STATE OF MISSOURI
DEPARTMENT OF NATURAL RESOURCES

December 30, 1992

SANITARY LANDFILL INSPECTION REPORT

West Lake (Bridgeton) Sanitary Landfill
Laidlaw Waste Systems, Inc.
St. Louis County
MDNR Permit #118912

BRIDGETON LANDFILL
PREPARED 3/20/93
GLENN A. O'BRYAN
ATTACHMENT TO LETTER
OF 3/20/93

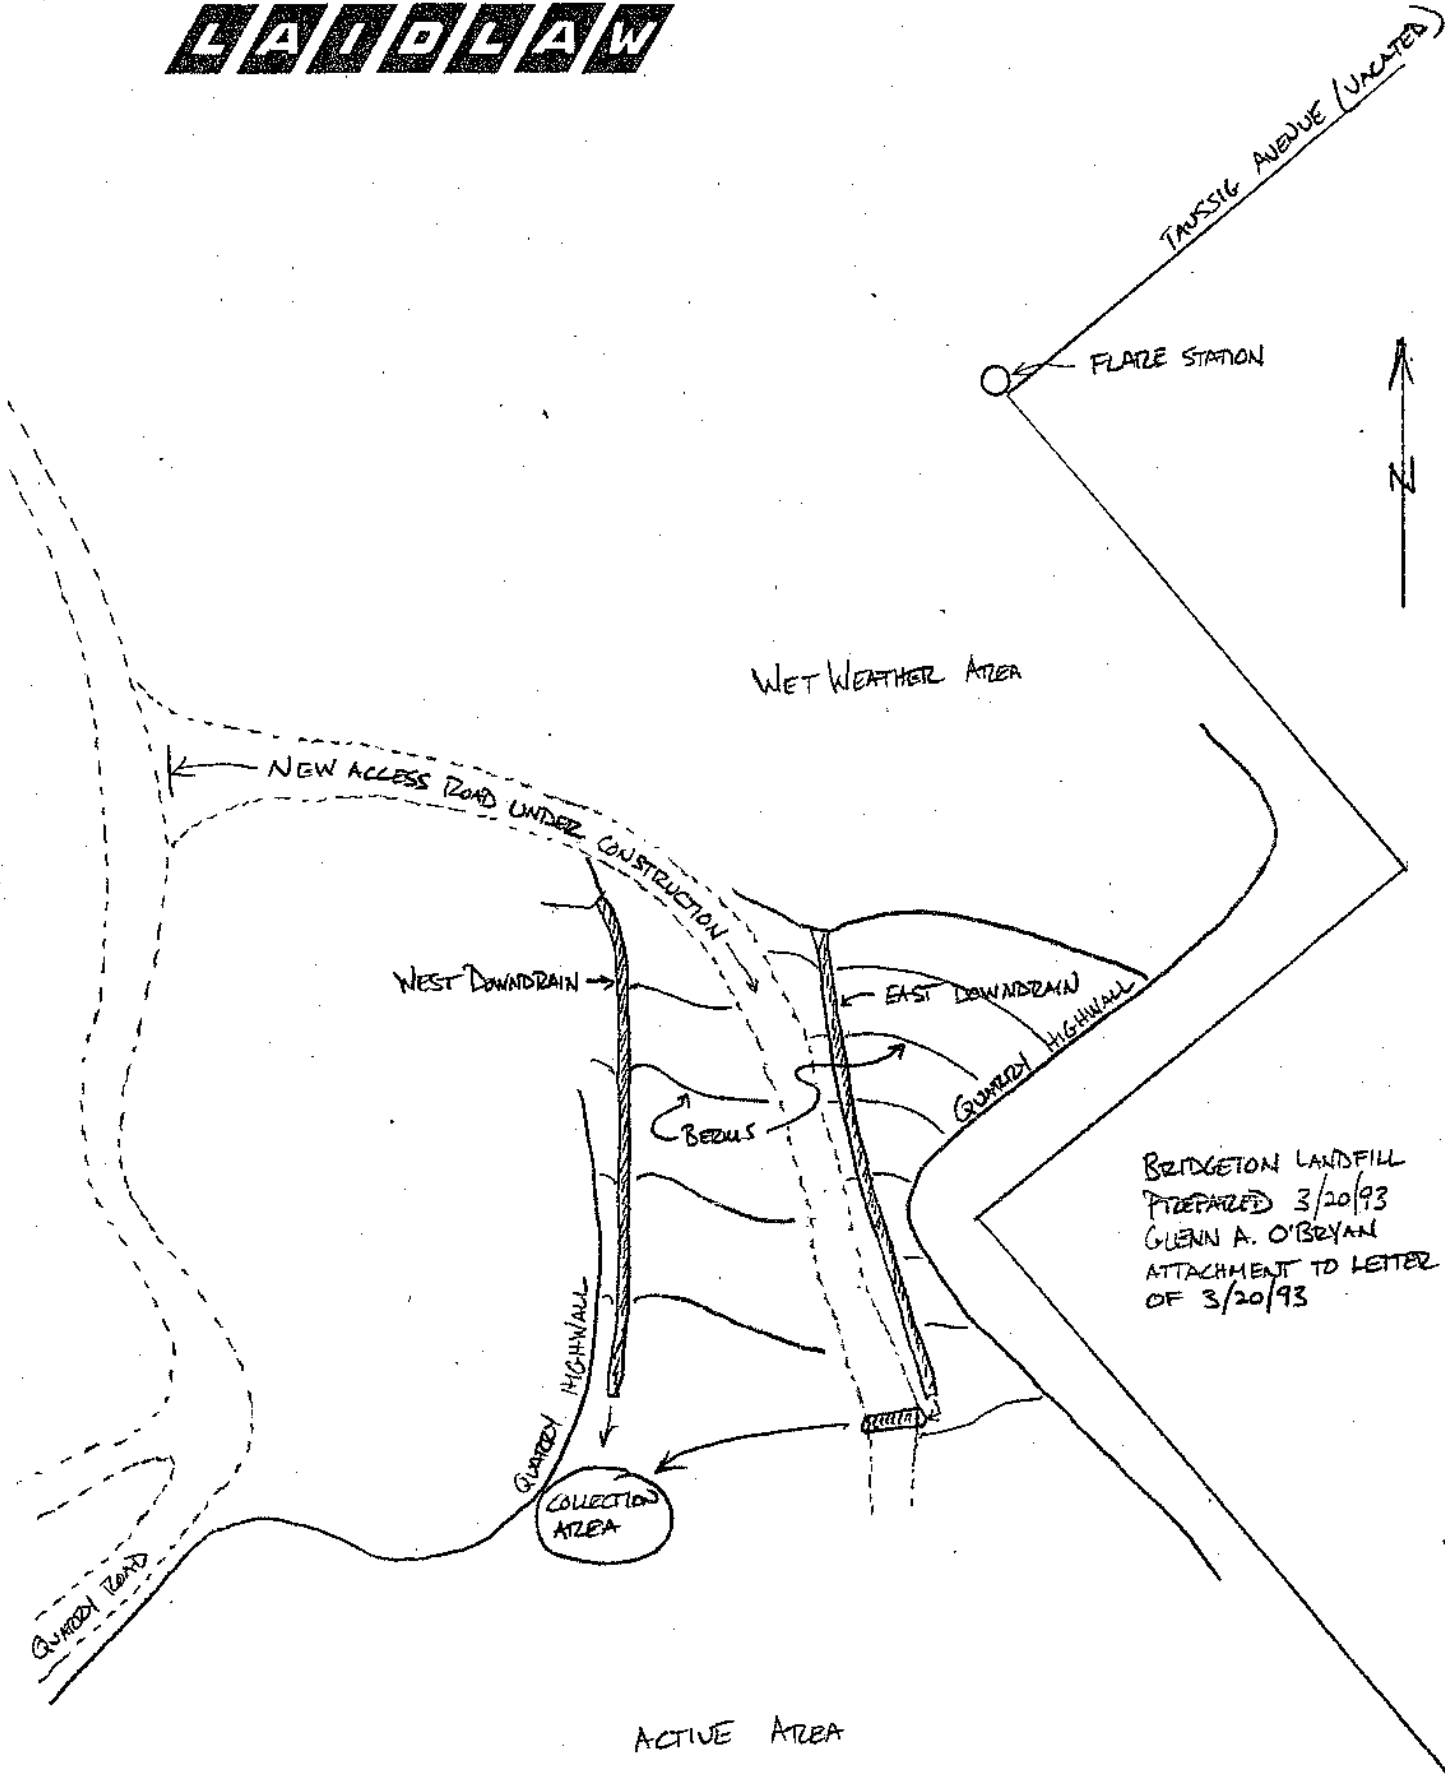
This office is requesting Laidlaw to submit in writing within two (2) weeks from receipt of this inspection an implementation schedule to correct violations [Section 607.730.11 (surface water courses diverted and proper grading as indicated) and 607.760.15 (surface water not contacting waste)]. If corrections have not been completed within the specified schedule, legal notification may ensue.

Regarding 607.730.11 (surface water courses diverted and proper grading as indicated) and 607.760.15 (surface water not contacting waste), please find attached a sketch describing the corrective construction features. The corrective construction features include an all-weather access road, west downdrain, east downdrain, erosion control berms, additional cover soils and vegetation. The road has been under construction during the past month, and should be completed by April 15. The road will provide a solid path for our heavy equipment to move between the sanitary site and the demolition site. We may also use this new road for refuse vehicle ingress and egress, particularly when maintenance is required for the main quarry road. Completion of the road will allow access for performing the additional work. I plan to complete the construction of the cover soils, berms and other drainage features by May 15.
